Cabinet Member for City Services

Report – Objections to Proposed Waiting Restrictions

Appendix A – Summary of proposed restrictions, objections, letters of support and responses

Extract of plan showing original proposal at Myrtle Grove

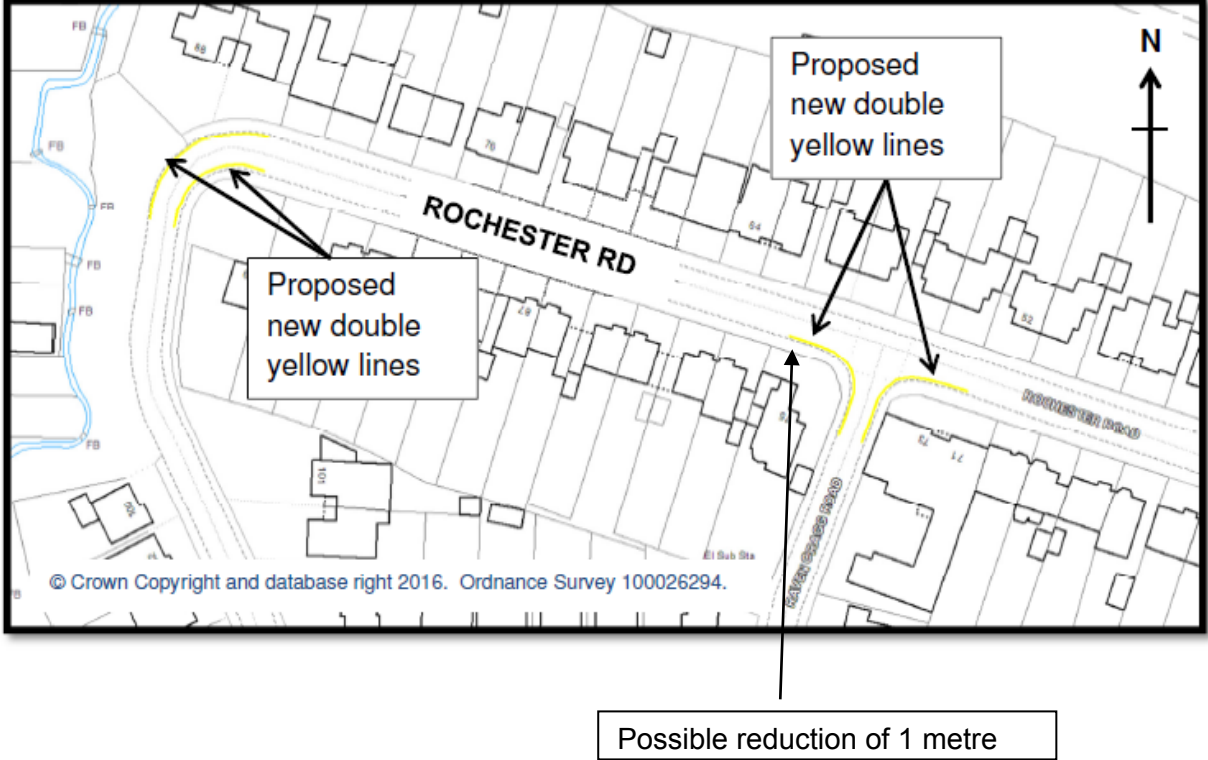
<p>Objection 29</p>	<p>Re Myrtle Grove</p> <p>Whilst I don't entirely disagree with the idea for safety purposes, I don't think it should be introduced without further serious consideration for the parking permits r, a similar measure or at least a reduction in the area the double yellow lines will be applied.</p> <p>We live directly opposite xxxxx and it is very common that there is no where to park when we get home from work due to parents taking up spaces to collect their children as opposed to using the purpose-built drive through. It also becomes very difficult to park on the weekends due to people leaving their cars on Moor Street and walking down to the pubs/bars.</p> <p>Whilst we do avoid parking on the Myrtle Grove bend whenever possible, we have often had to park as far away as Hartington Crescent and walk through the alley way when both Moor Street and the corner concerned are full; not so bad in the summer but when it's dark in the winter it can be unnerving. The proposed double yellow lines look as though they will remove at least 5 spaces -some of which are actually on Moor Street- and will only make the parking situation worse.</p> <p>It seems unnecessary to place lines outside of 124-128 Moor Street as your map suggests. Cars parked outside of these properties have never seemed to stop large vehicles such as refuse lorries from getting to Myrtle Grove.</p> <p>I ask that for the time being you take this as an objection on the grounds of it removing too many spaces unnecessarily which will cause further parking issues for residents unless other measures are also introduced.</p>

Objection 30	<p>Re double yellow lines at the end of Myrtle Grove, we do not understand why, there have being problems in the past with the dustbin men not being able to get past to collect the bins ,but this is not any of the residents that park there.</p> <p>wouldn't it be much better to have residents only parking only, as it is a problem parking in myrtle at the best of times, everyone after our house has off street parking.</p>
Objection 31	<p>Re Myrtle Grove</p> <p>.I imagine this is due to the difficulty in accessing Myrtle Grove at times by the refuse collectors. The residents of the Grove are aware of collection days and ensure the road is clear for their access.</p> <p>I feel i am being punished for the acts of non- residents parking in front of my property. I have lived here for 30 years and it is only recently that there appears to be a problem. It is evident parking generally in Earlsdon is a problem and i feel that the proposed double yellow lines outside my house will seriously devalue my property.</p> <p>I have no alternative parking as most of the Grove has off road parking.</p> <p>May i suggest a more reasonable proposal in order to not punish the home owners would be to introduce resident only parking. This would hopefully solve the parking as well as access problems.</p> <p>May i also mention that today on 20th of July 2016 there were no vehicles parked in Myrtle Grove at the time of the refuse collections.</p>

Response to objections	<p>A consultation was undertaken, following a petition from residents, asking residents if they were in favour of implementing a residents parking scheme in their area. 38% said yes, 43% said no</p> <p>The main requests raised in the petition were to reduce the existing lengths of the double yellow lines at the junctions and to remove the limited waiting restriction on Arden Street.</p> <p>Keeping safety in mind and to allow some additional parking spaces, it was proposed to reduce the existing double yellow lines at the junctions. This will not hinder access to or egress from any street. Earlsdon neighbourhood comprises of residential, retail and commercial premises.</p> <p>Therefore parking allowance needs to be made for all.</p> <p>Civil Enforcement Officers regularly patrol the Earlsdon area, however, they cannot be present every day.</p> <p>After reviewing the bend and the width of Myrtle Grove and due to road safety concerns, it is proposed at the very least to introduce double yellow lines on one side of the bend. Therefore, it is proposed that the double yellow lines are not introduced on both sides of Myrtle Grove but only on the southern side.</p> <p>Recommendation – do not install the proposed double yellow lines on Myrtle Grove on the northern side of the road (only installing the double yellow lines on the southern side of the road). Install the reduction in double yellow lines as proposed..</p>
